Access Compliance Report

Public Rights-of-Way

Intersection ID: 14762	Main Street: E_TREMONT_AV	Cross Street: SPRINGDALE_AV	Location: S
ADA ID: E406BA395FFE	Ramp Type: BlendTrans1	Initial Pass/Fail: Fail	Overall Compliance: No
Severity Score: 1.25			
Codes/Mitigation Info/Possible Solution		Field Measurements/Component Compliance

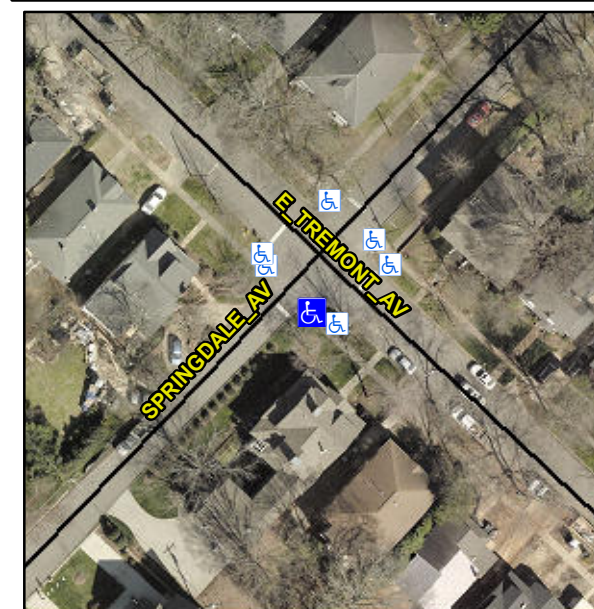
DWS WARPED

R304.5.3

Compliance	Description	Data	Compliance	Description	Data
N/A	Ramp Length (in)	76.5	Yes	BlendTrans Slope (%)	2.8
Yes	Ramp Width (in)	48.0	No	BlendTrans XSlope (%)	2.9
N/A	Flare Type LT	N/A	N/A	Flare Type RT	N/A
N/A	Flare Slope LT (%)	N/A	N/A	Flare Slope RT (%)	N/A
N/A	Flare Traversable LT?	N/A	N/A	Flare Traversable RT?	N/A
N/A	Landing Length (in)	N/A	N/A	DWS Provided?	N/A
N/A	Landing Width (in)	N/A	N/A	DWS Contrast?	N/A
N/A	Landing Slope (%)	N/A	N/A	DWS Length (in)	N/A
N/A	Landing X Slope (%)	N/A	N/A	DWS Full Width?	N/A
N/A	Landing Curb? (Y/N)	N/A	N/A	DWS Offset (in)	N/A
N/A	Shared Landing?	N/A			
N/A	Gutter Ponding?	N/A	N/A	Gutter Slope (%)	N/A
N/A	Gutter Lip Ht (in)	1.0	N/A	Gutter X Slope (%)	N/A
N/A	Painted X Walk1?	No	N/A	Painted X Walk2?	N/A
	X Walk 1 Direction	To NW		X Walk 2 Direction	N/A
	X Walk 1 Width (in)	N/A		X Walk 2 Width (in)	N/A
	X Walk 1 Slope (%)	3.8		X Walk 2 Slope (%)	N/A
	X Walk 1 X Slope (%)	4.2		X Walk 2 X Slope (%)	N/A

Remove & Replace Curb Ramp With Two New Directional Ramps or Equivalent.
